**STAFF REPORT 10-9-2019 MEETING**  
**APPLICATION NUMBER 19-6493**  
**ADDRESS: 4120-4128 SECOND**  
**HISTORIC DISTRICT: WILLIS SELDEN**  
**APPLICANT: TONYA STAPELTON AND BLAKE HILL**  
**DATE OF COMPLETE APPLICATION: 8/26/2019**  
**DATE OF STAFF SITE VISIT: 10/1/2019**

**SCOPE: REHAB BUILDING AND ERECT A NEW SIDE ADDITION**

ITALIAN MARKET & PIZZERIA LOCATED AT 4120 SECOND AVE

DETROIT HDC SUBMISSION (REVISED) - 9.26.19

**SOUTH ELEVATION B**

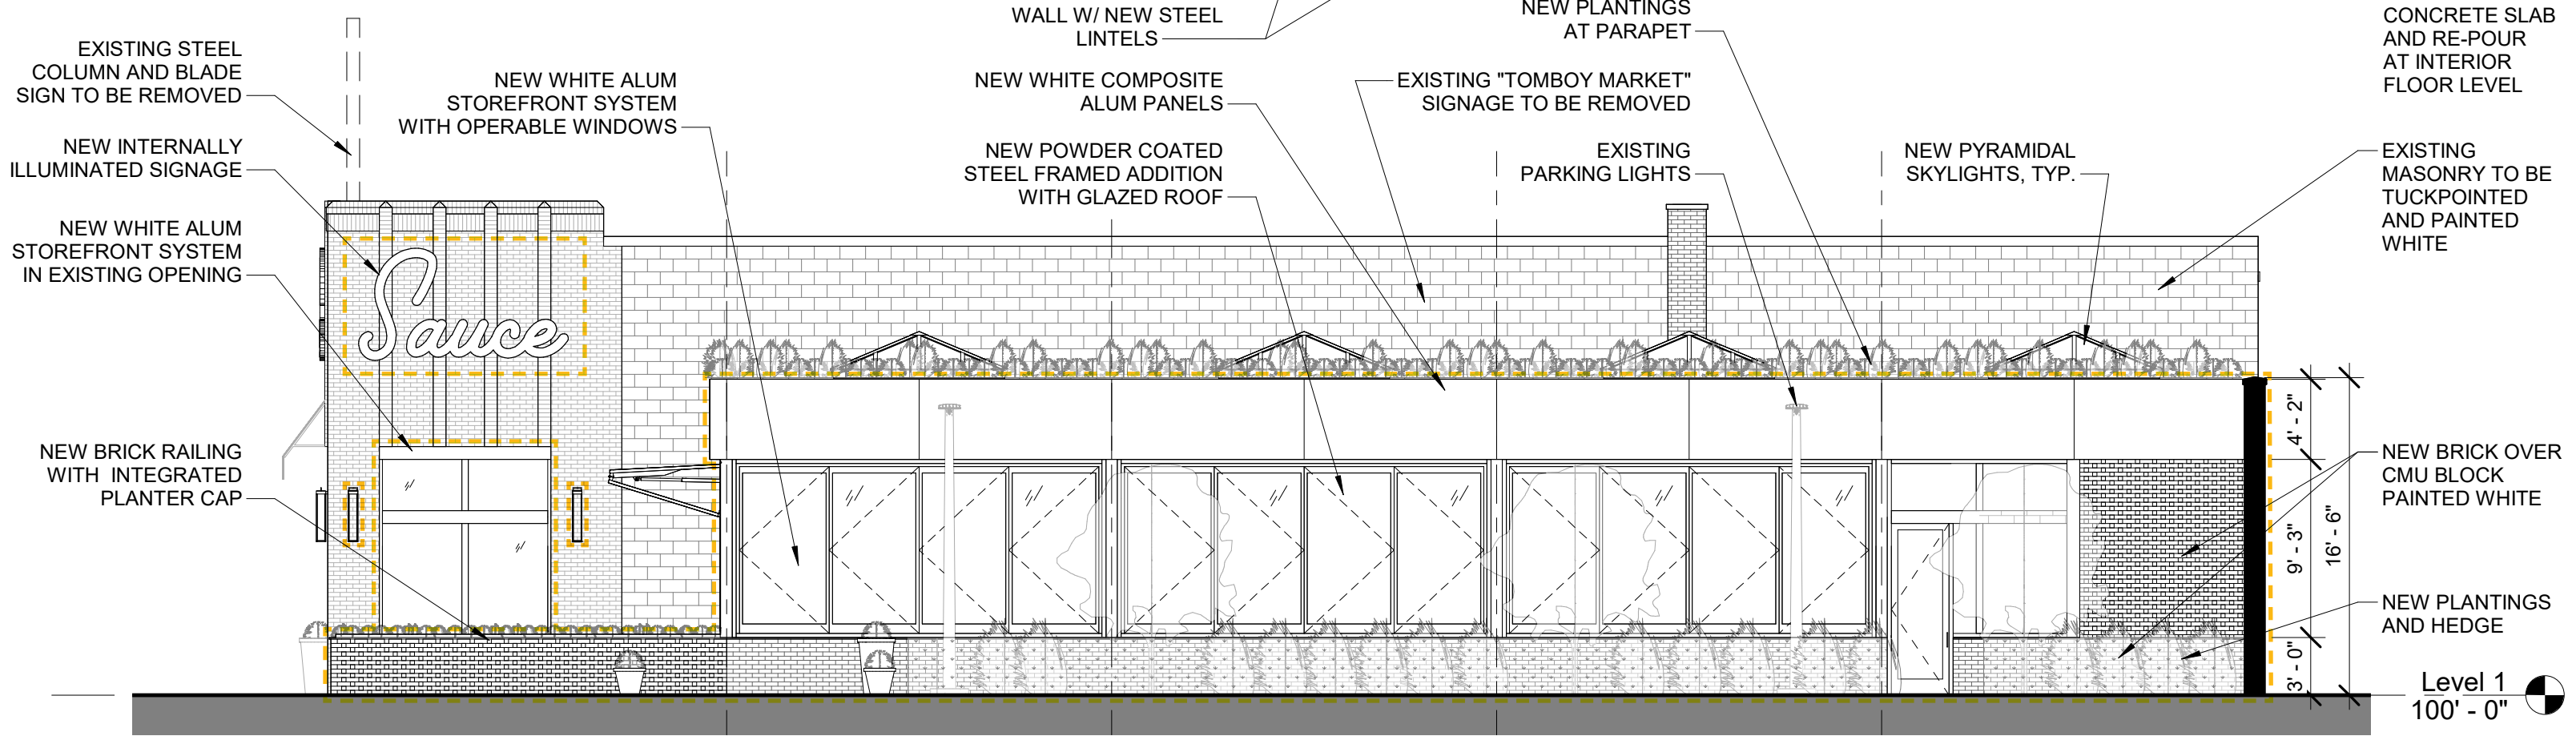
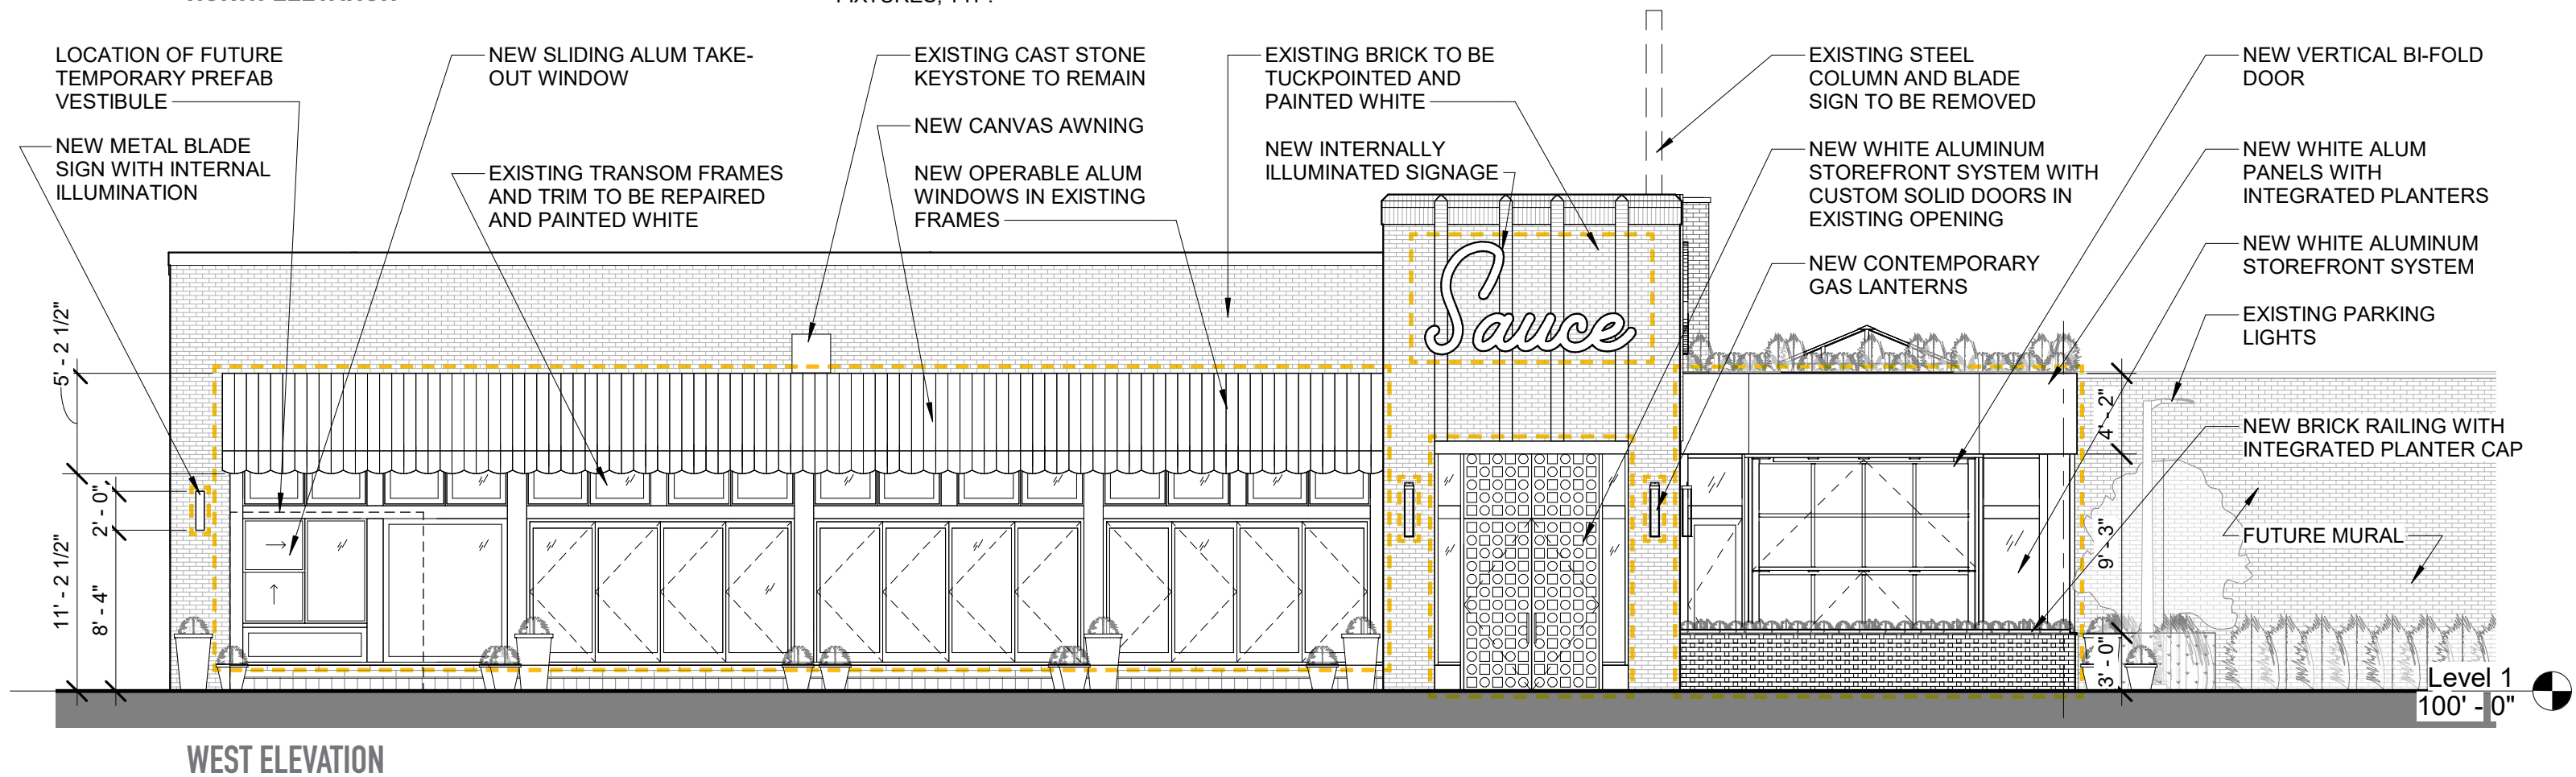
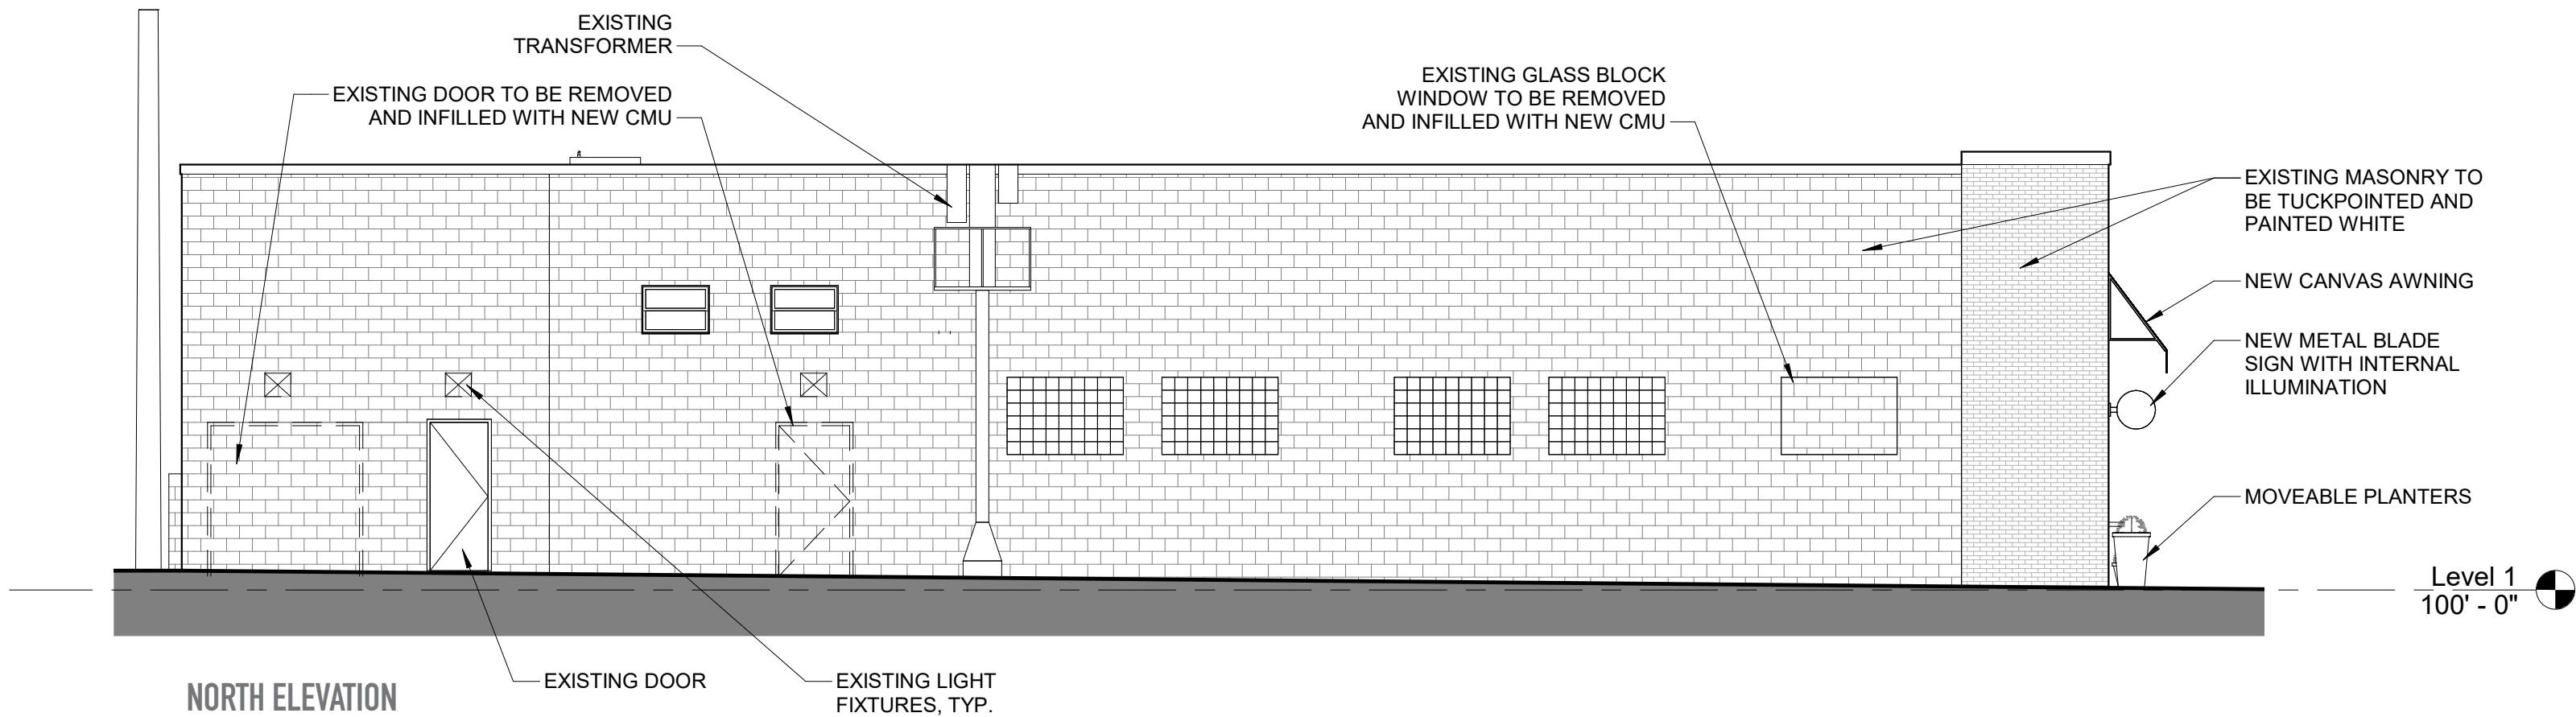
- The applicant proposes to paint unpainted brick at the building's front elevation
- See <https://www.nps.gov/tps/standards/rehabilitation/rehab/masonry01.htm>, in which the National Park Service does not recommend "applying paint or other coatings such as stucco to masonry that has been historically unpainted or uncoated..."
- The applicant proposes to install three new internally-illuminated signs.
- The new addition will be highly visible. However, it is staff's opinion that it will be compatible with the massing, size, scale, and architectural features of the existing historic building while remaining distinct as a new addition

- The unpainted masonry at the front elevation shall not be painted
- The applicant shall submit a final full signage application to HDC staff for review and approval. Should staff determine that the work does not meet the Standards, staff shall forward the proposal to the Commission for review at a future meeting
- The applicant shall submit a final mural proposal (for the new rear wall) to HDC staff for review and approval prior to the work. Should staff determine that the work does not meet the Standards, staff shall forward the proposal to the Commission for review at a future meeting
